**EXTRACT FROM COUNCIL MEETING MINUTES OF SEPTEMBER 26, 2017**

**SITE DEVELOPMENT FILE DA.17.027**

**2523360 ONTARIO INC.**

**WARD 2 - VICINITY OF LANGSTAFF ROAD AND HUNTINGTON ROAD**

## Proposed Site Plan

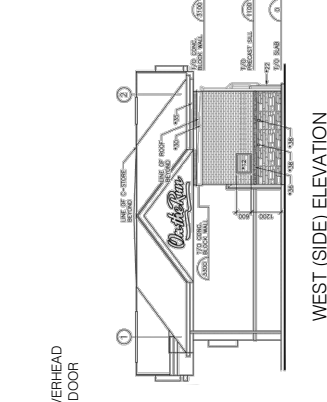
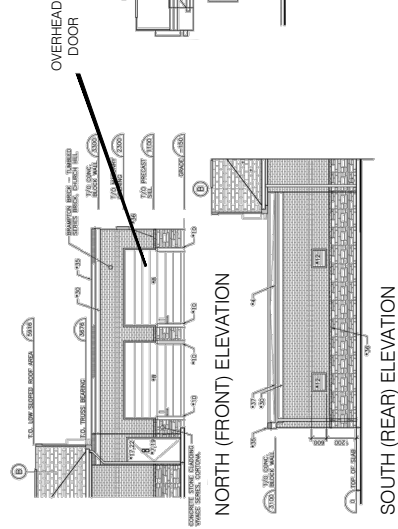
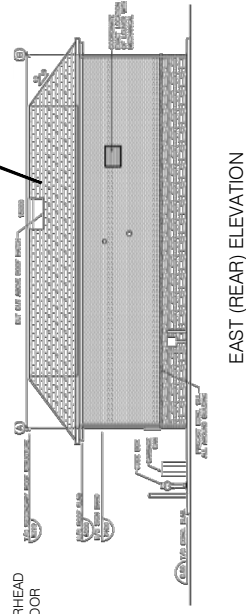
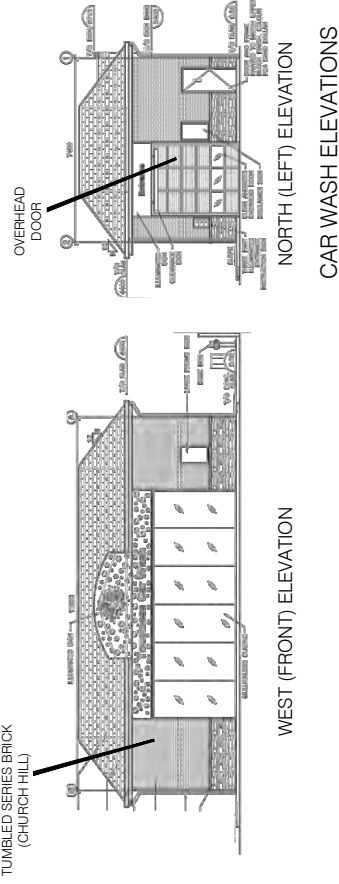
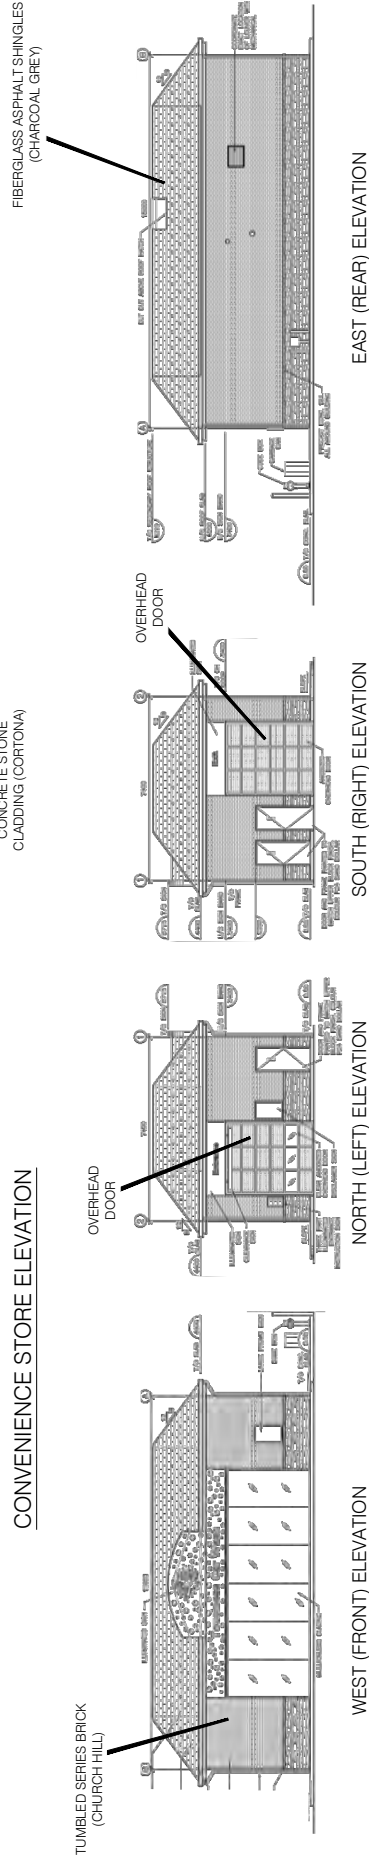
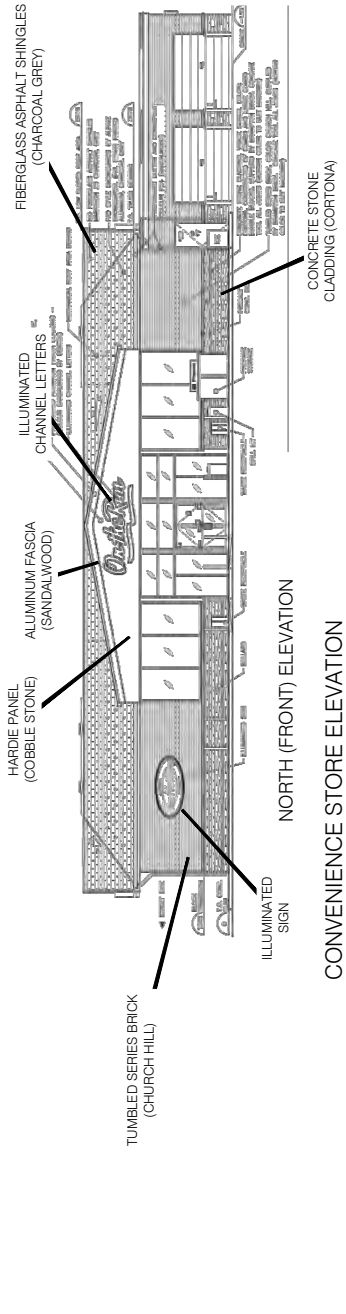
The proposed site plan shown on Attachment #3 includes 20 temporary truck parking spaces. The Owner has indicated that these parking spaces will not be used for the outside storage of trucks. The Owner has submitted written confirmation indicating that truck parking will only be permitted for a 2-hour maximum period, and that no overnight parking will be permitted. The proposed site plan, as shown on Attachment #3, also includes temporary parking signage.

The subject lands are a corner lot with the yard abutting Langstaff Road deemed to be the front yard and the yard abutting the south lot line the rear yard. The definitions within Zoning By-law 1-88 do not contemplate having vehicle and truck fueling stations on the same site. The proposed diesel truck fuel pumps are sited in an appropriate location on the subject lands based on the site layout and intended functions. The proper movement of vehicular traffic, internal and external to the site, and from the access driveways from Huntington Road and Langstaff Road will not be impacted by the location of the truck pump island.

A variance is required to reduce the minimum interior side yard for the car wash building. The stacking and vehicle exit route for the car wash are designed to allow for the proper vehicular movement through to the car wash and will not adversely impact the abutting lands to the east. A landscape treatment along the easterly yard of the car wash, as shown on Attachment #6, is proposed to provide partial screening and mitigate any visual impact.

The Parks Development Department has no objection to the proposal. The Owner shall ensure that a municipal walkway is constructed to provide a continuous trail network in this area. Municipal sidewalks are proposed on Huntington Road and Langstaff Road, as shown on Attachment #3.

# Proposed Convenience Store, Car Wash and Garbage Enclosure Elevations

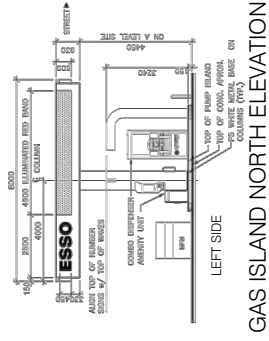
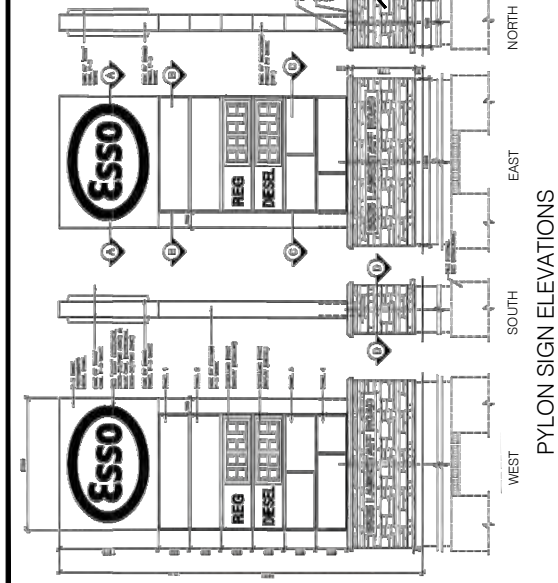
The proposed building elevations for the retail building and car wash consist of materials including brick, pre-cast concrete, stone cladding base, aluminum siding, fibre-glass asphalt shingles, pre-finished aluminum fascia cladding, and glazing as shown on Attachment #4. Illuminated signage is proposed for the car wash and drive-through facility shown in Attachments #4. The Owner is proposing stone cladding bases beneath the pylon signage, retail building, and car wash to enhance their design and compliment the gateway feature. Exterior light fixtures affixed to the building facades and yard lights are also proposed to provide lighting for safety reasons. The proposed gas bar canopy elevation, site signage (including pylon signs) are shown on Attachment #5. The site plan indicates that the digital billboard is proposed to the adjacent pylon sign on Langstaff Road. The Owner will be required to provide the design details related to the billboard sign, which must be reviewed and approved by the Development Planning Department.

Garbage and recyclables will be fully enclosed within the main building, as shown on Attachment #4. Front end bins will be rolled outside to a staging area in front of the overhead doors for garbage

## Gateway Entry Feature

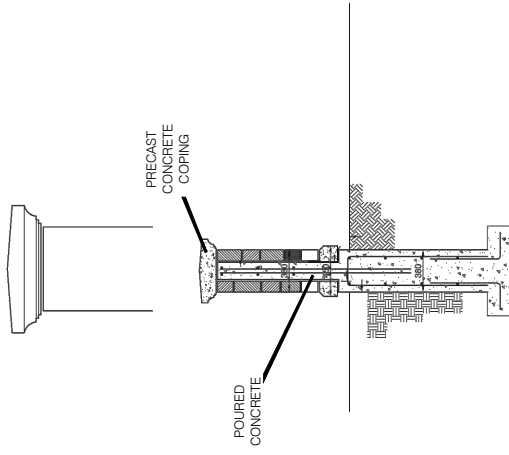
In consultation with the Urban Design and Cultural Heritage Division of the Development Planning Department, the Owner has provided additional enhancements to the landscape design to create a character for the gateway entry. A minimum 1.5 m wide landscape strip along the side lot line and a minimum 2.5 m wide landscape strip with plantings have been proposed to partially screen the abutting properties. Enhanced tree plantings are proposed within the landscape strips abutting Huntington Road to provide partial screening of the truck parking spaces, as shown on Attachment #6.
